Appeal against approval of DP2014-1557 at 55 - 28th Avenue SW

I'm here on behalf of the Erlton Community Association. We fully support Mr. Turner in his appeal against this discretionary development.

SHADOW WITH
 .5/12 PITCH
 1.2 M SETBACK
 6.0 M DEPTH
 8 FOOT CEILING HEIGHT

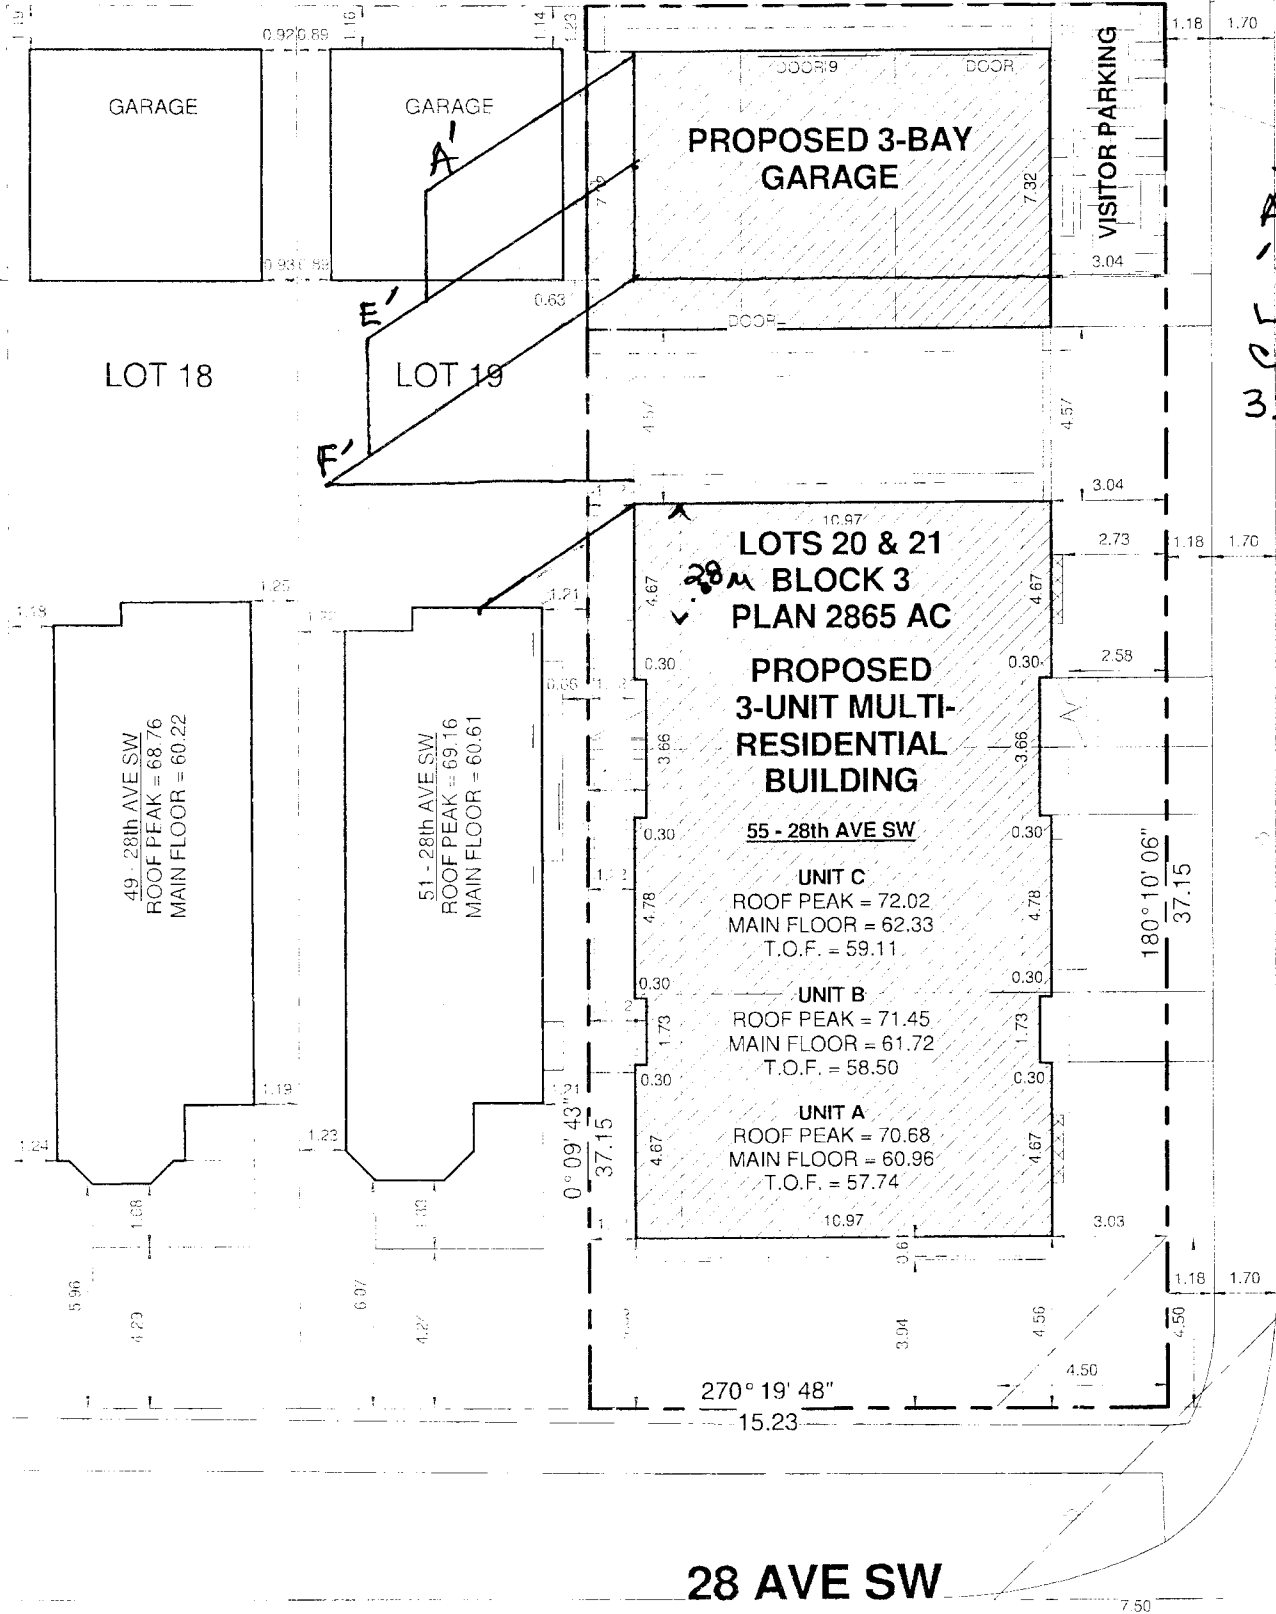
Drawing #5 shows a large improvement when an 8-foot ceiling height is coupled with a .5/12 roof pitch, a 1.2m side setback, and a 6.0m garage depth. It results in a noticeable reduction in shadowing to the rear yards of both homes.

A MISSING
 MARK -
 LENGTH IS
 CORRECT @
 3.23 CM. Rear-

We support Mr. Turner in his application to deny this development permit or effect substantial changes to the garage to eliminate the negative impact of its design and location on the lot. We strongly support a 0.5/12 roof pitch to match that of the main building, a 1.2m east property line setback, a reduced garage depth of 6.0m, and a ceiling height of 8 feet. These changes would mitigate the severe shadowing of the two backyards to the east. It would also allow the gas and electric meters to be moved to the east wall of the garage to improve the visual aspect of the west facade (plan DP5 - upper right), which faces Erlton's major north/south roadway.
